Addendum No. 1 **February 6, 2025**

#### City Project No. 23-067 Package 1 **Roads Program Capital Improvement Project**

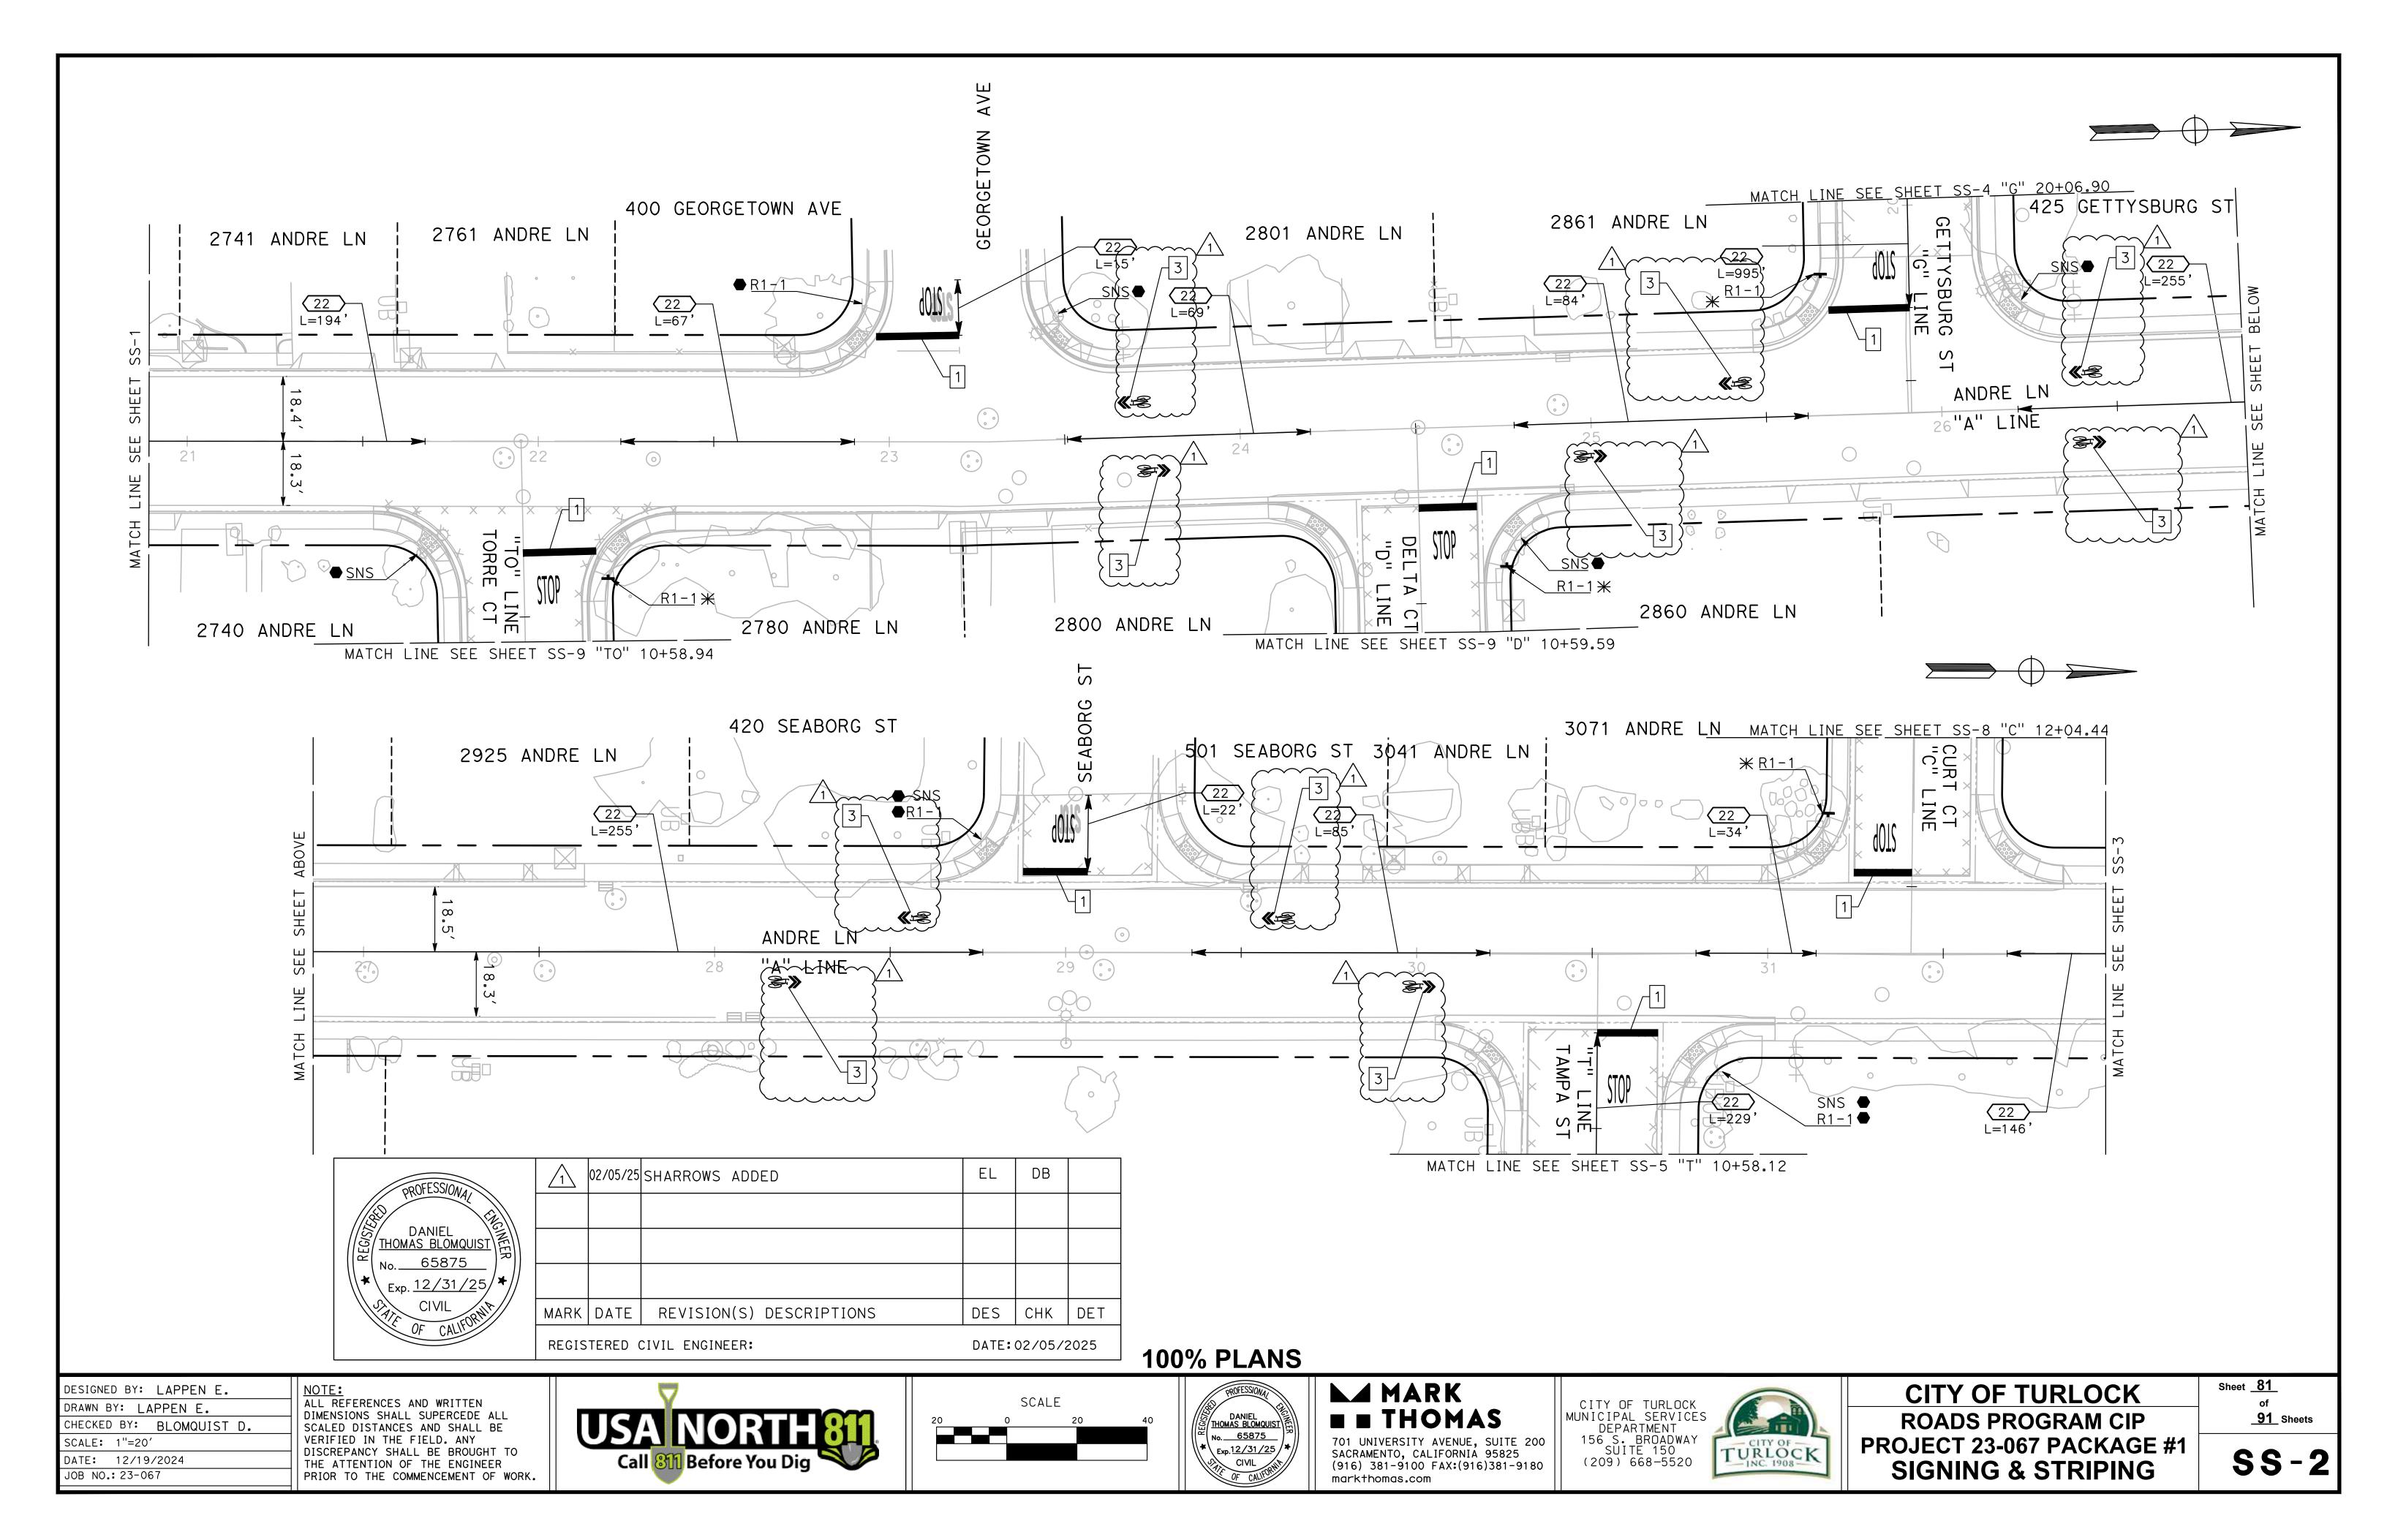
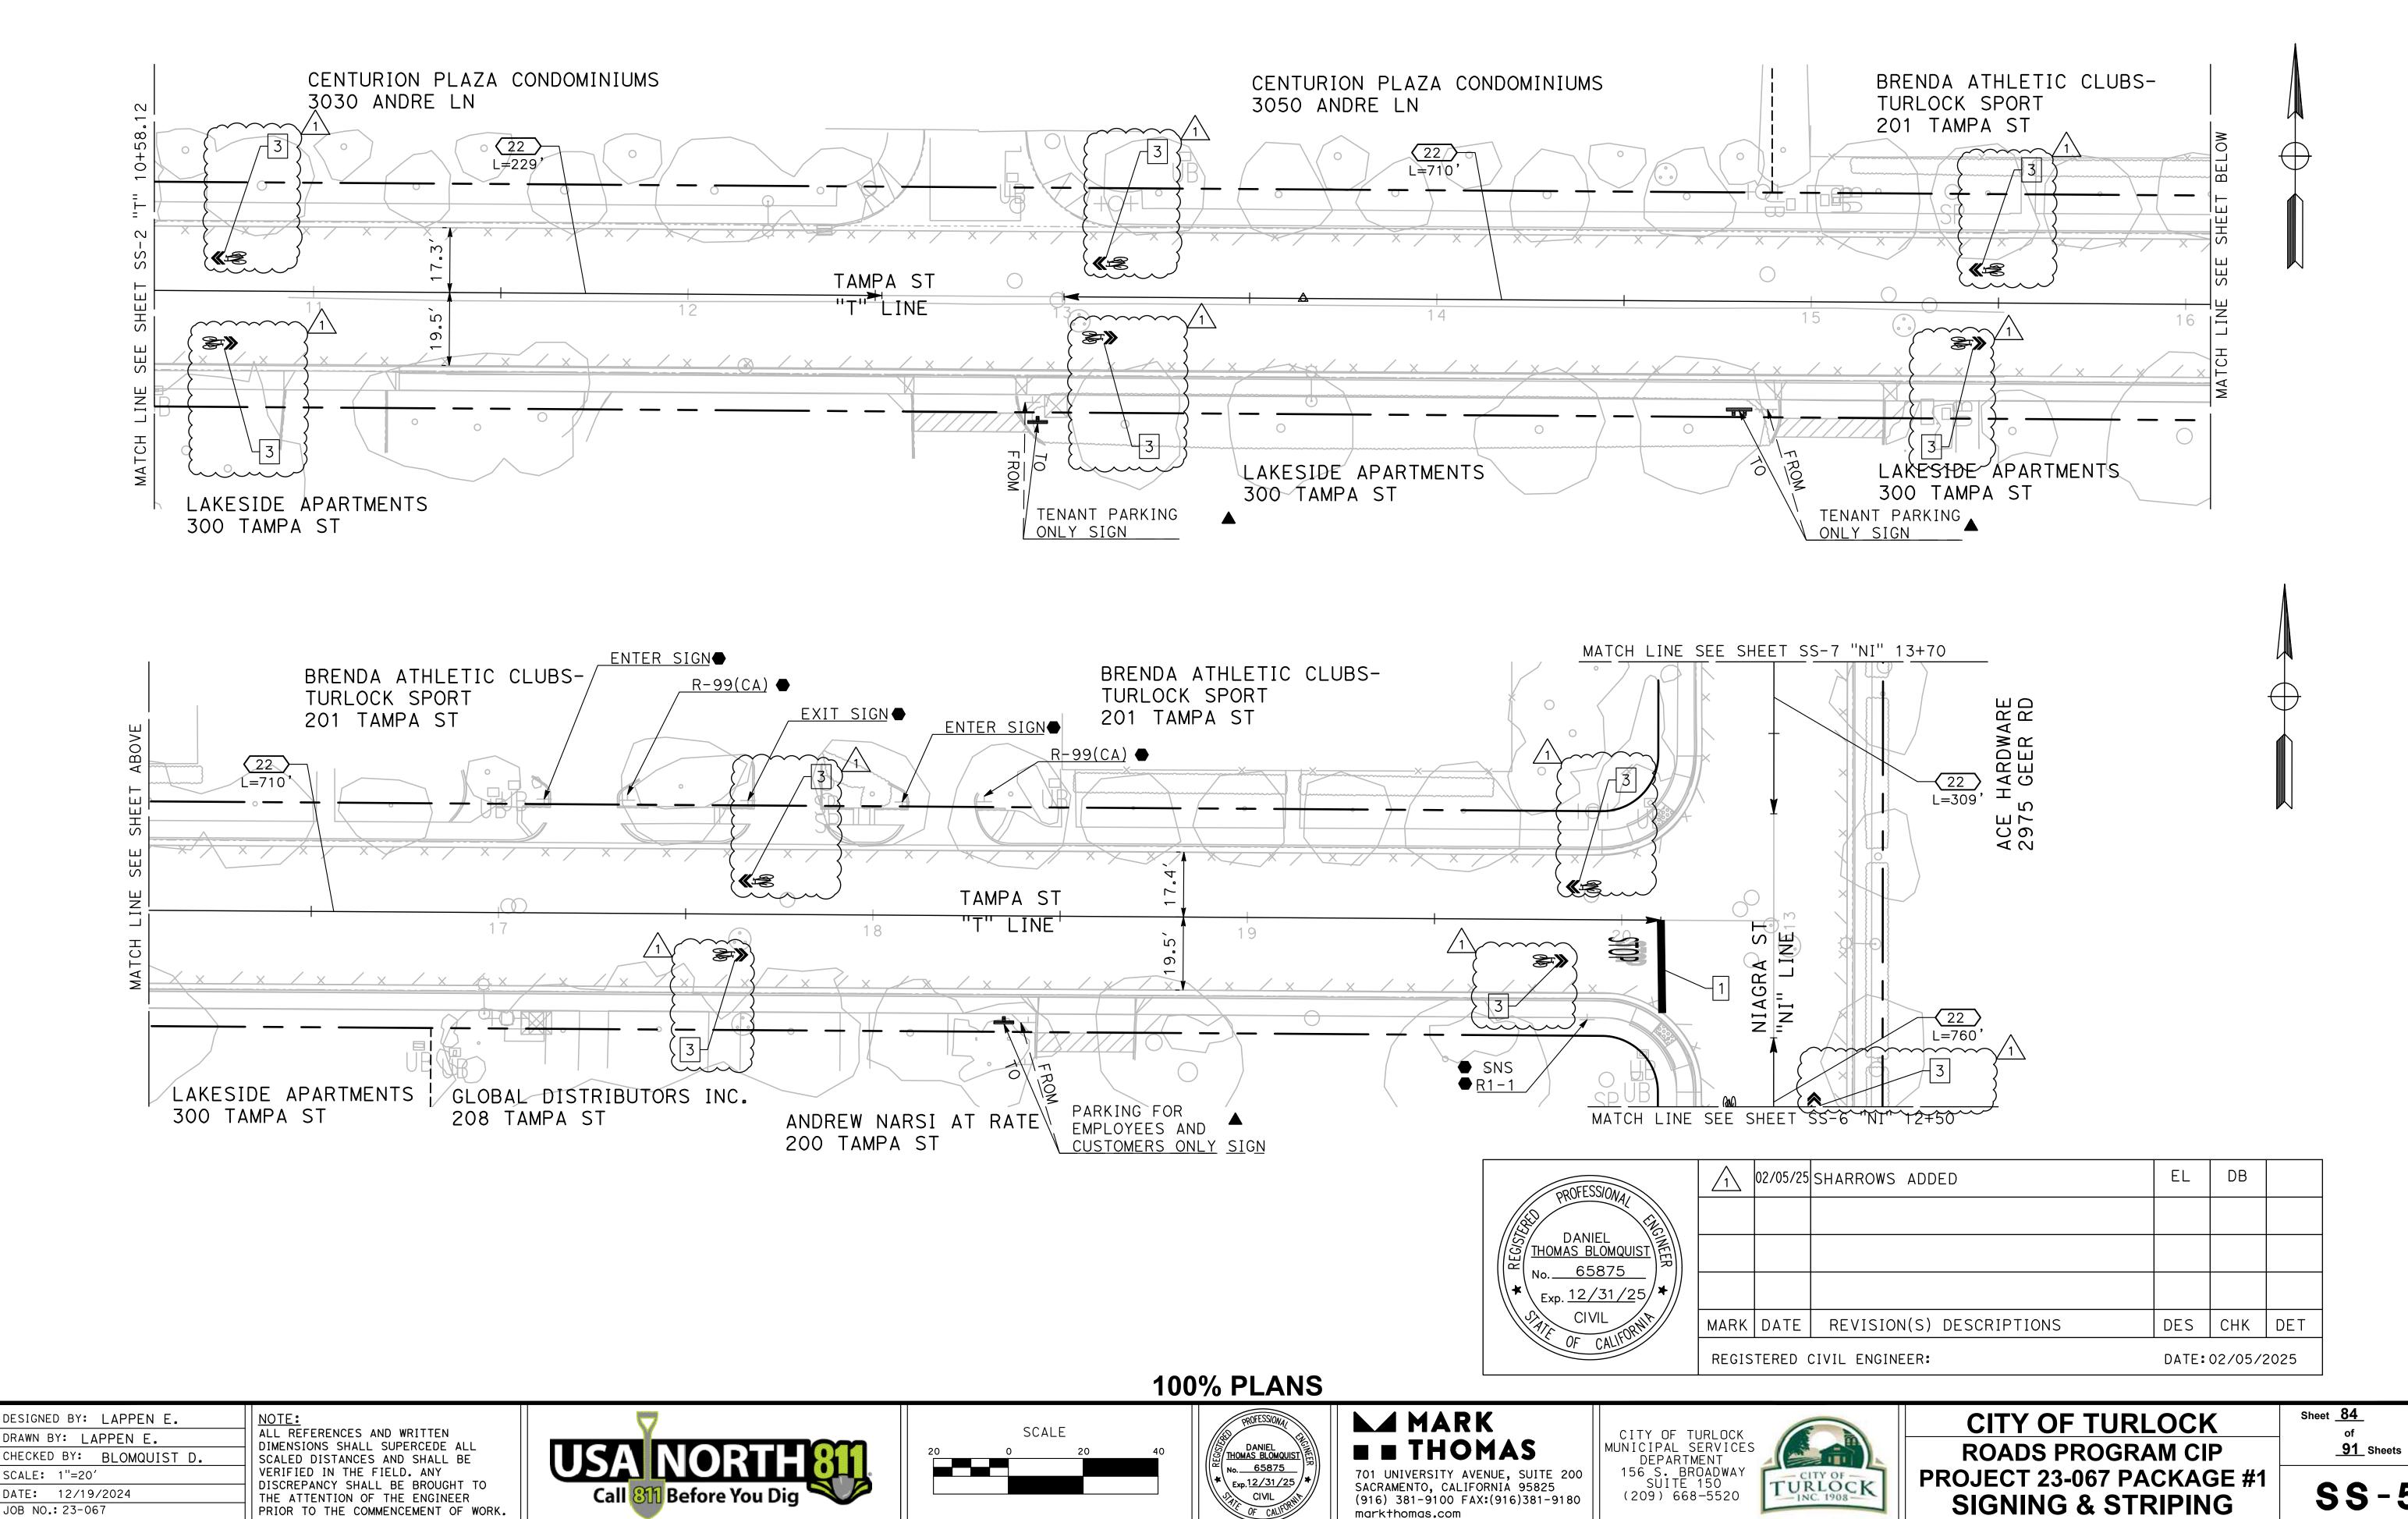
**Q1:** Looking for some clarification on the plans for project 23-067, Sheets DM-1 through DM-9 of the demolitions plans are showing a hatch pattern on all the Cul-de-sacs is denoting "Roadway Excavation" according to the legend, is this correct or should it be one of the cold plane hatch patterns?

A1: Cul-de-sacs will be included in Bid Item 11 – Roadway Excavation (F)

**SS-5 SIGNING & STRIPING**

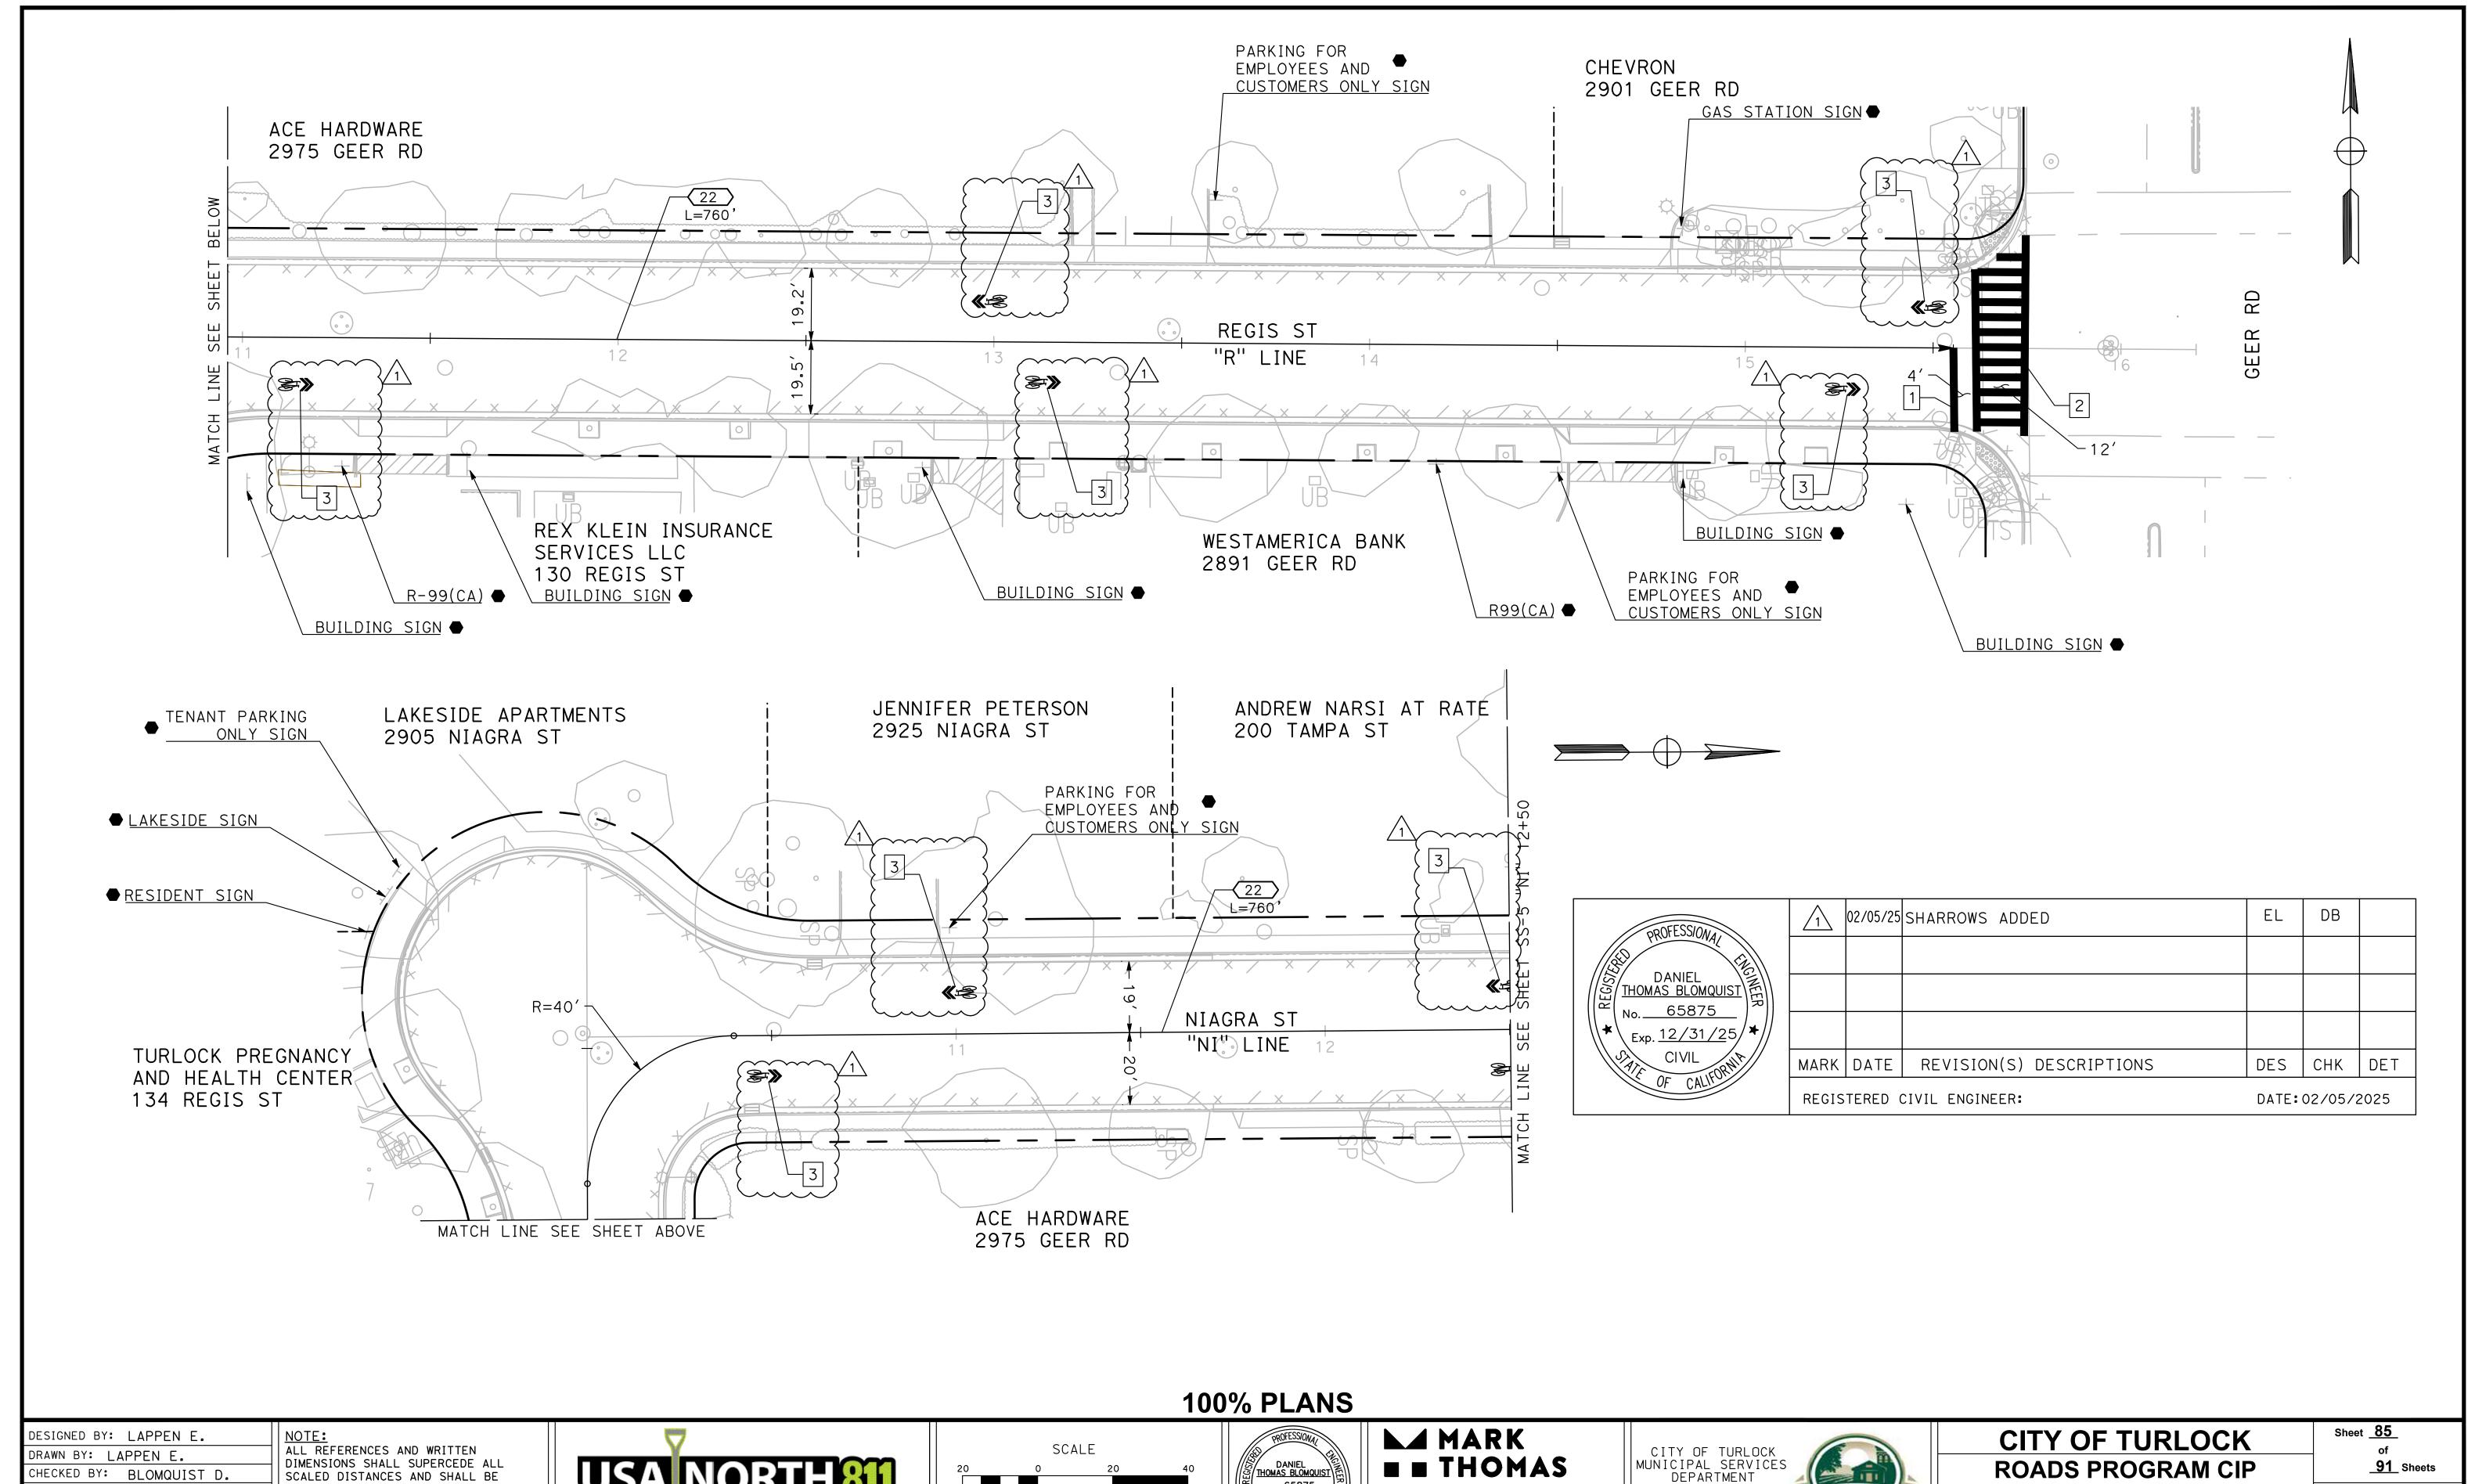
Delete sheets SS-1, SS-2, SS-5 and SS-6 and replace with attached sheets SS-1, SS-2, SS-5 and SS-6 of this addendum. Revisions consist of adding Sharrows along the following streets: Regis Street, Niagra Street from Regis Street to Tampa Street, Tampa Street, Andre Lane from Tampa Street to Georgetown Ave.
